RESPONSES TO COMMENTS FROM THE NEZ PERCE TRIBE ON THE DRAFT IN SITU REDOX MANIPULATION FIELD INJECTION TEST REPORT - HANFORD 100-H AREA, JUNE 1996, PACIFIC NORTHWEST NATIONAL LABORATORY, RICHLAND, WASHINGTON

Effects of Dispersivity on Instantaneous Release of Reduced Uranium

## U(VI) Behavior in Dithionite Reduced Sediments

One Dimensional Uranium Transport Modeling - Dispersivity = 2 m

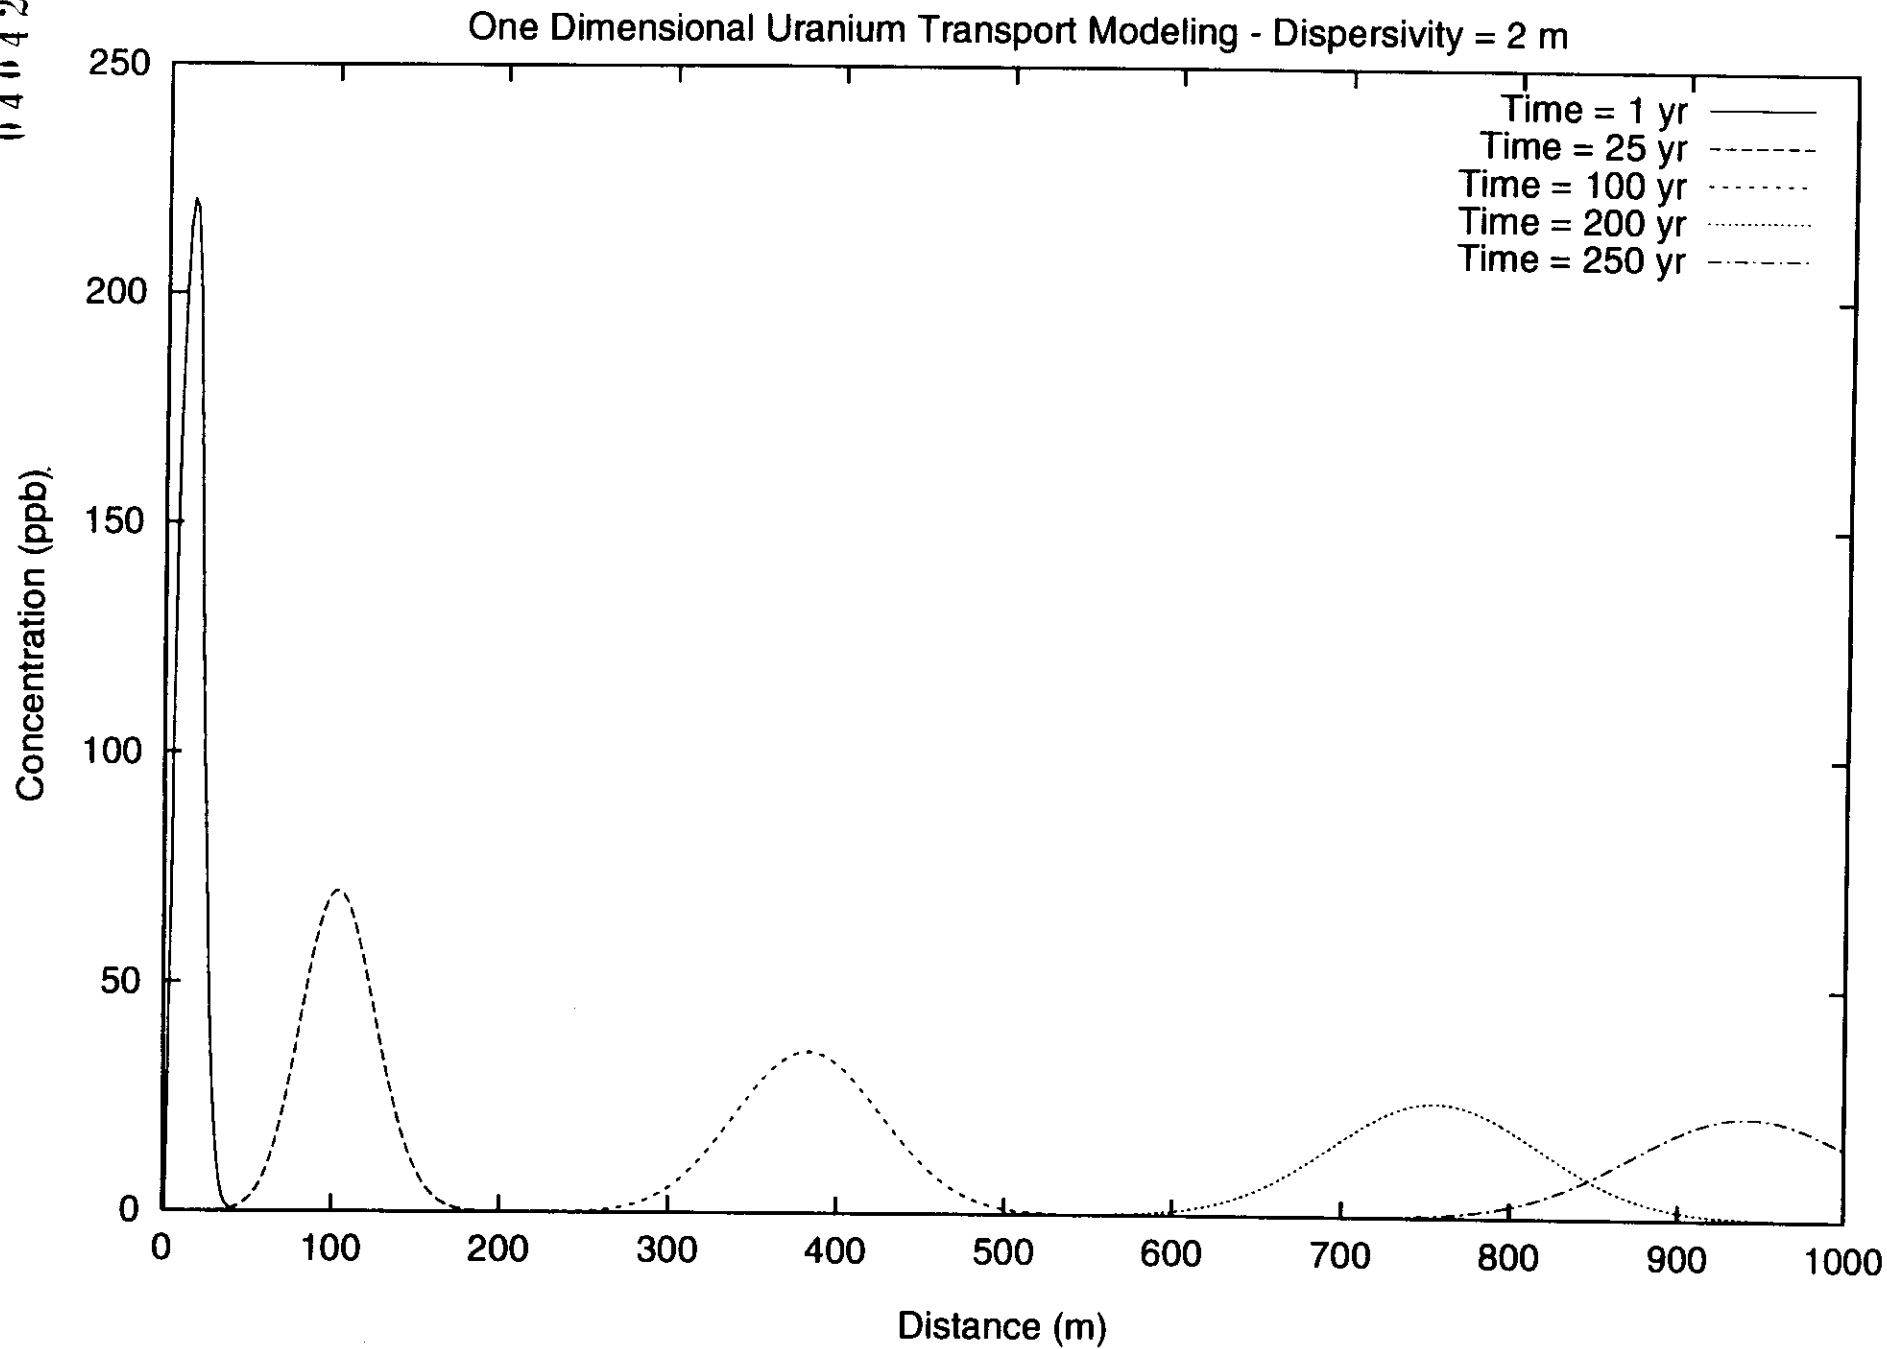
Results of the modeling are shown in the attached figures. These results show the concentrations at fixed points for three different values of dispersivity and at two different groundwater flow rates. Overall, the results show that significant attenuation occurs for the uranium plume by dispersion over the flow path and the resulting plume is reduced from the peak concentration of 230 ppb in the reduced zone to less than 13% of the peak value at a distance of 1000 m, the distance from the proposed site to the Columbia River.

# Uranium Behavior in Dithionite Treated Hanford Sediments

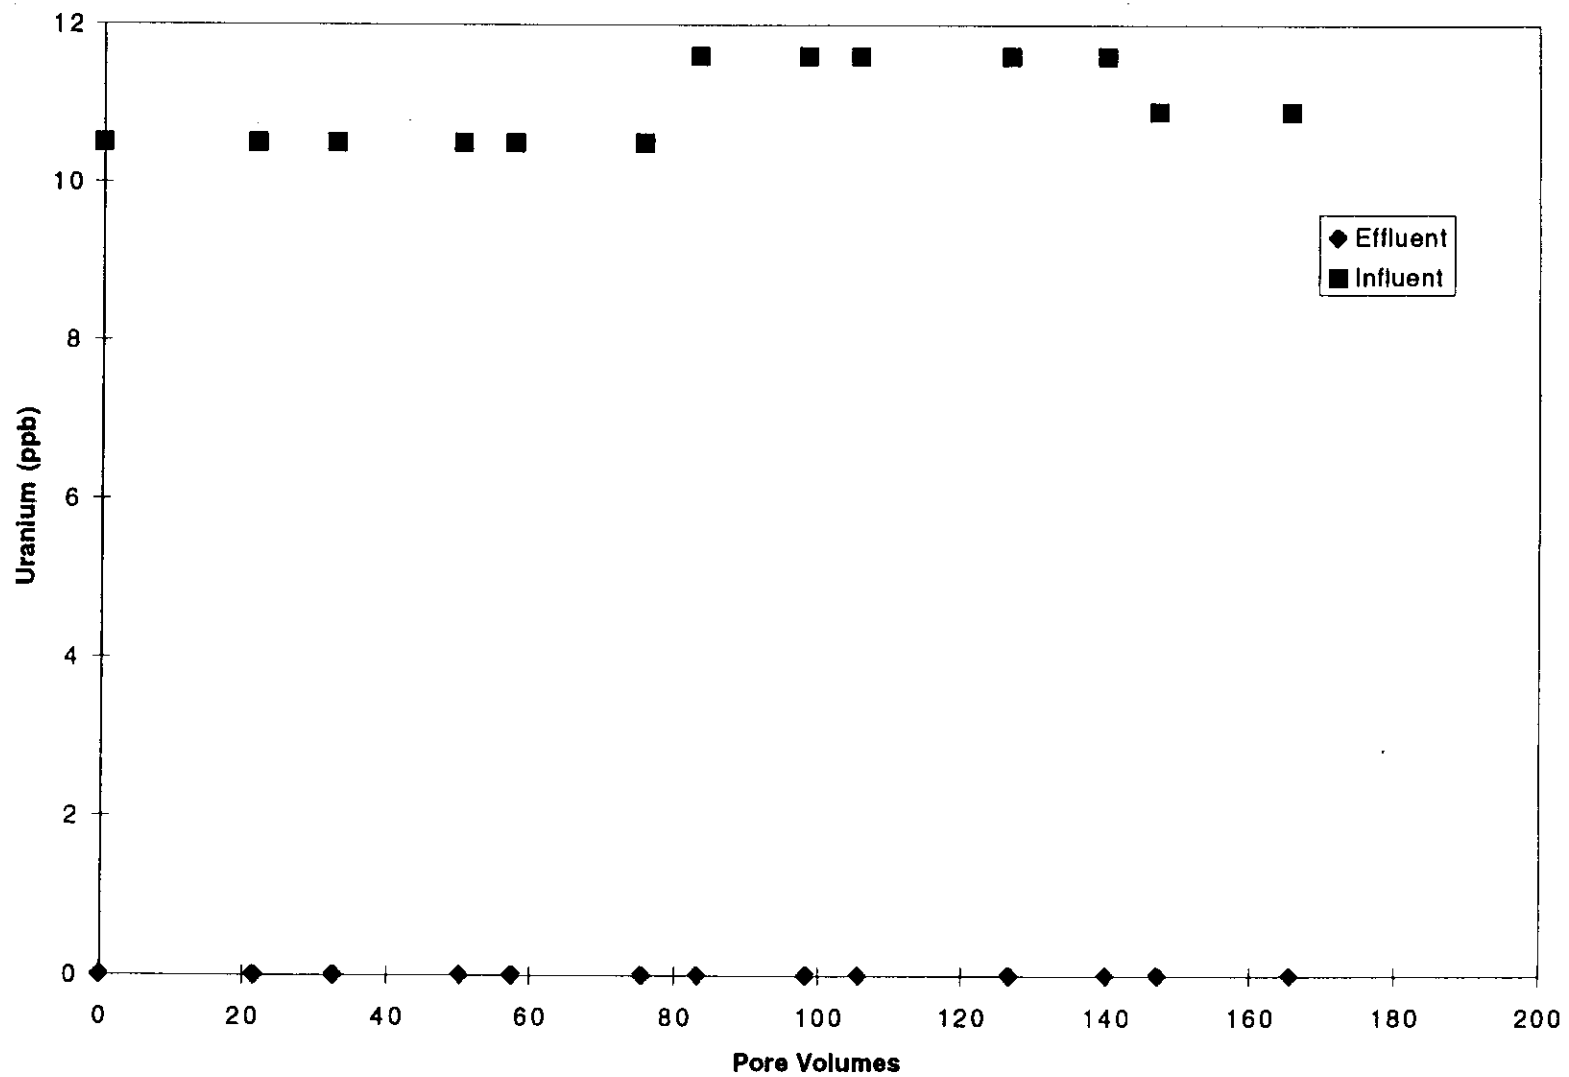
A total of 1656 ml (166 pore volumes) of solution was pumped through each column. Samples were collected at various intervals during the course of the experiment. At no time during the experiment was any uranium detected in the effluent of the column. The results are shown on the accompanying figure.
